No Gain Preliminary Plan of Subdivision, 1-20130170

Staff Report Date: 2/14/14

- Staff recommendation: **Approval** with conditions
- The applicant seeks to subdivide three parcels into two one family lots. The property is located within the Village of Chevy Chase, Section 5.

Preliminary Plan

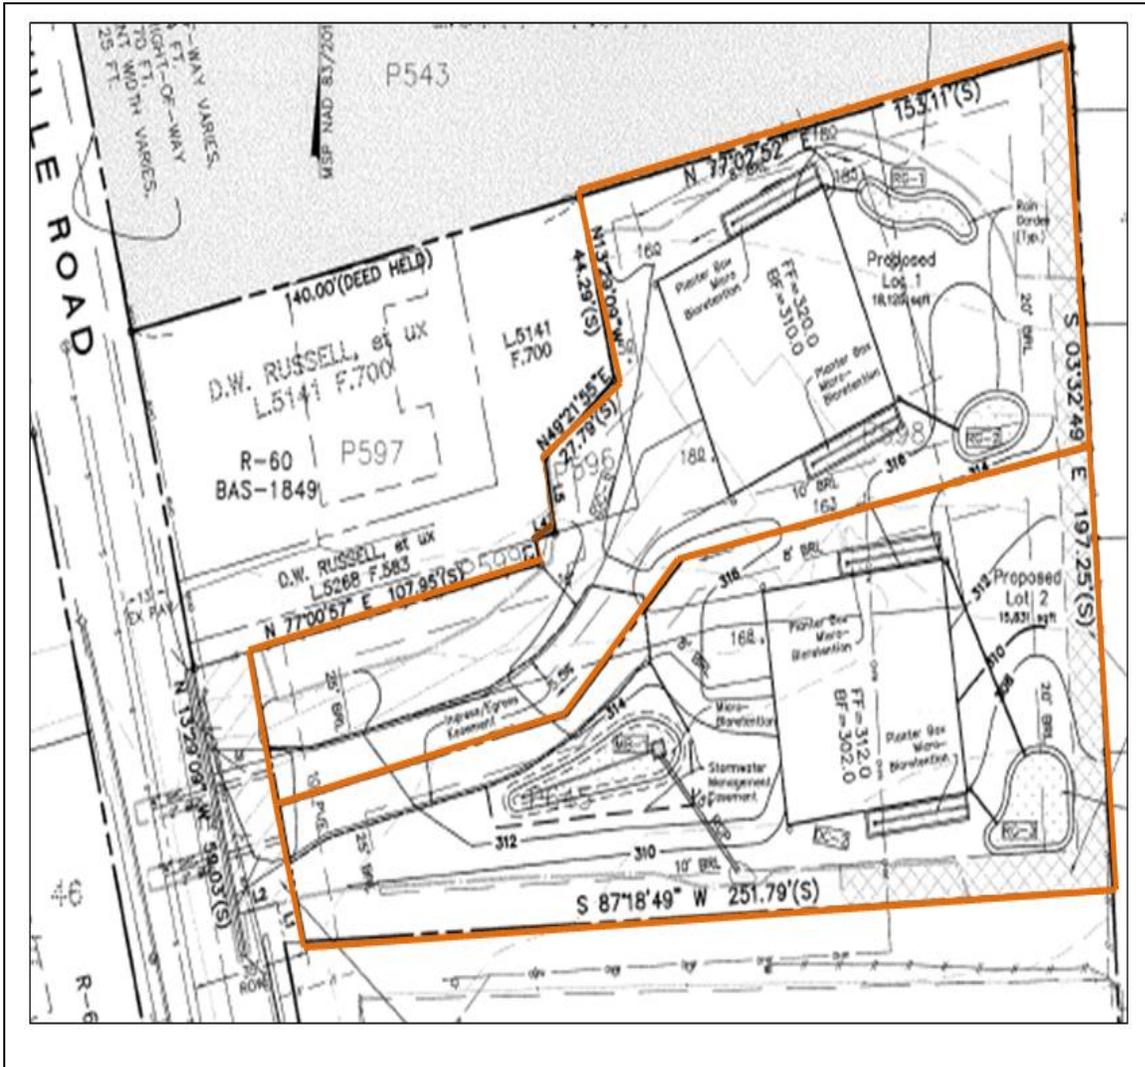
RECOMMENDATION: Approval subject to the following conditions:

- 1) This Preliminary Plan is limited to two lots for two one-family dwelling units.
- 2) The certified Preliminary Plan must contain the following note:
Unless specifically noted on this plan drawing or in the Planning Board conditions of approval, the building footprints, building heights, on-site parking, site circulation, and sidewalks shown on the Preliminary Plan are illustrative. The final locations of buildings, structures and hardscape will be determined at the time of issuance of building permit(s). Please refer to the zoning data table for development standards such as setbacks, building restriction lines, building height, and lot coverage for each lot. Other limitations for site development may also be included in the conditions of the Planning Board's approval.

- 5) The Applicant must dedicate and show on the final record plat 35 feet of right-of-way, for Brookville Road as measured from the existing right-of-way centerline, to provide a 70 feet wide right-of-way along the site's frontage as recommended in the 1990 Approved and Adopted Bethesda-Chevy Chase Master Plan.

- 6) The record plat must reflect common ingress/egress and utility easements over the shared driveway.
- 7) The fee-in-lieu payment or certificate of compliance to use an off-site forest mitigation bank that satisfies the 0.13 acre afforestation requirements must be submitted by the Applicant then approved by M-NCPPC staff prior to any clearing or grading within the project area.

PRELIMINARY FOREST CONSERVATION PLAN
PROPOSED LOTS 1 & 2
NO GAIN
L.34884 F.335, L5268 F.586 & L.4867 F.416
7TH ELECTION DISTRICT - MONTGOMERY COUNTY - MARYLAND

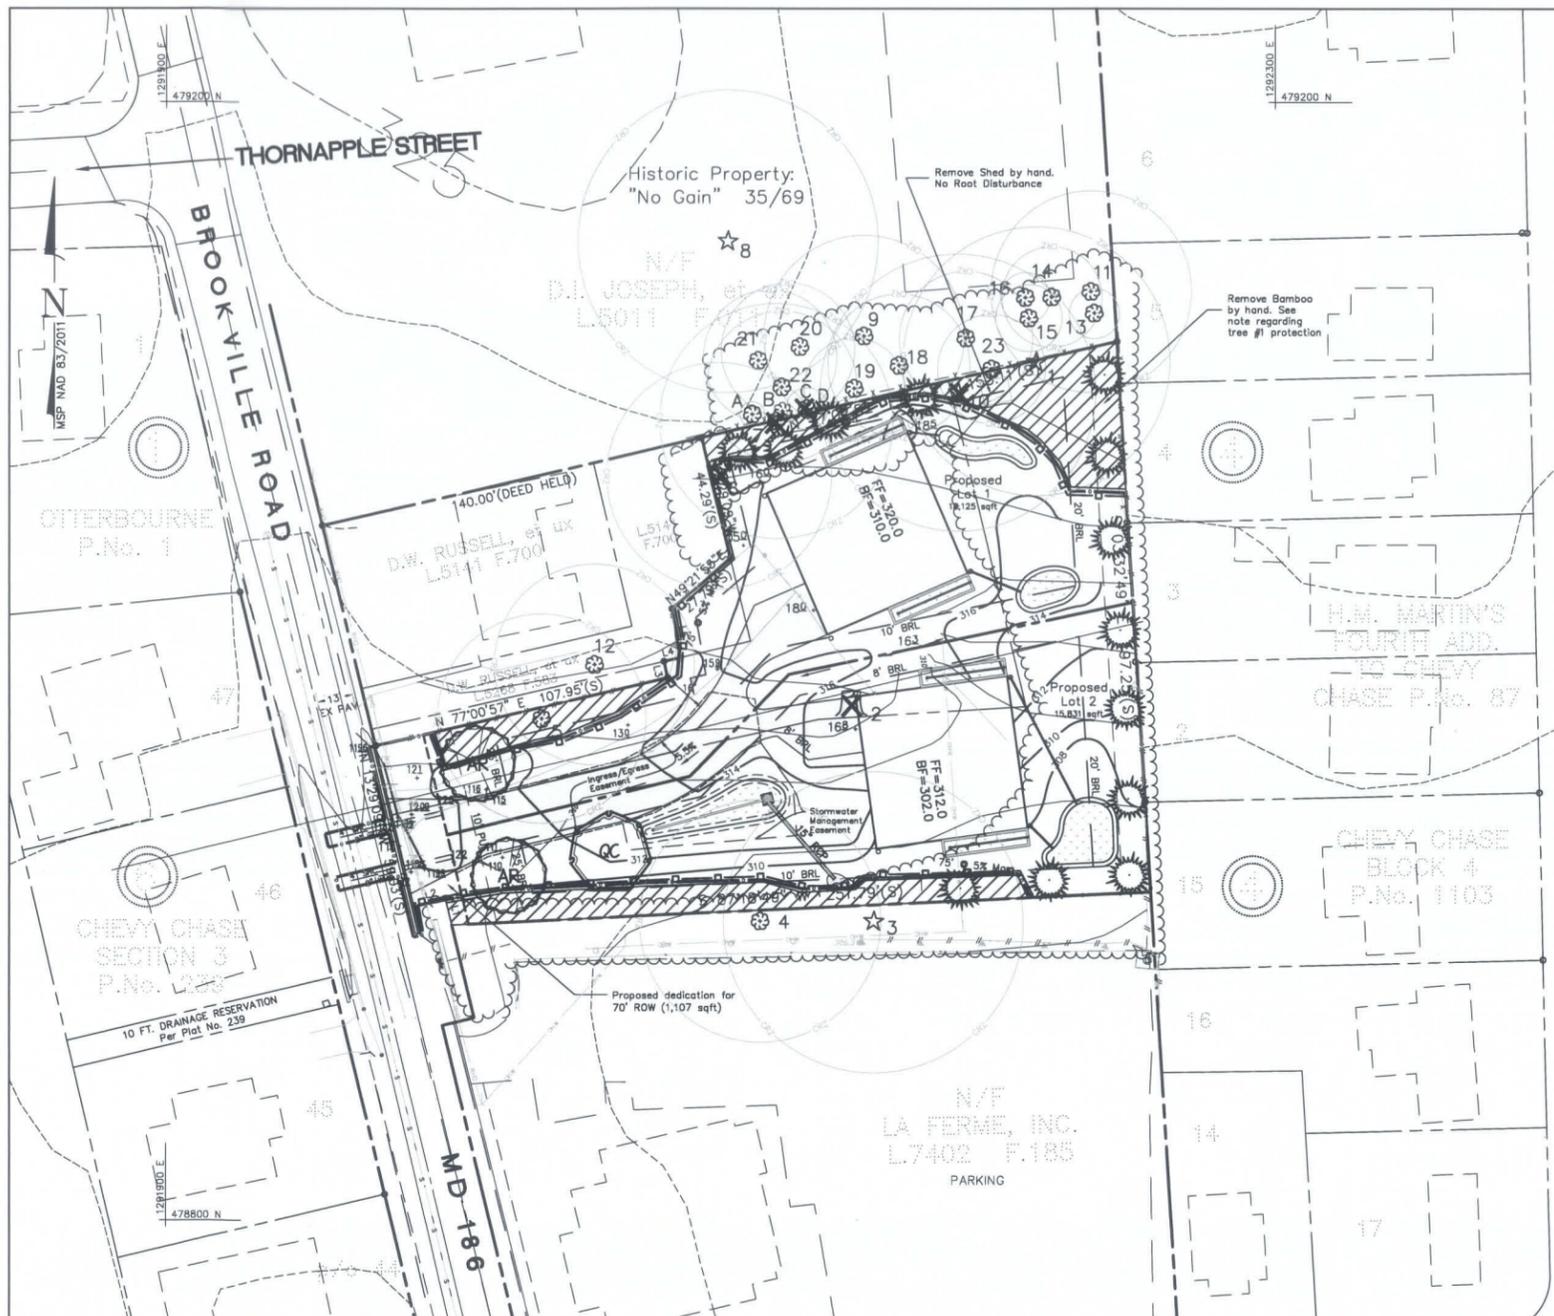
- 8) The Final Forest Conservation Plan must show and the applicant must install on-site six 3" - caliper native canopy trees to satisfy the tree variance mitigation requirements.

The applicant is not proposing mitigation for two of the subject trees due to the condition of the trees being listed as "poor", and is providing only three replacement trees on the submitted plans. The variance provisions do not have exceptions for tree health/condition, rather the law states that variance trees must remain in an "undisturbed condition." Staff has recommended a condition of approval requiring that the six mitigation trees be provided onsite. The October 3, 2013 letter from the County arborist letter supports the staff's position by recommending mitigation plantings even for trees in poor or hazardous condition. The installation of six trees does not include any plantings for the 54" silver maple that has already been removed and would have otherwise triggered the requirement of five additional trees (for a total of 11 replacement trees). Additionally no planting mitigation is recommended by staff for the trees impacted but retained.
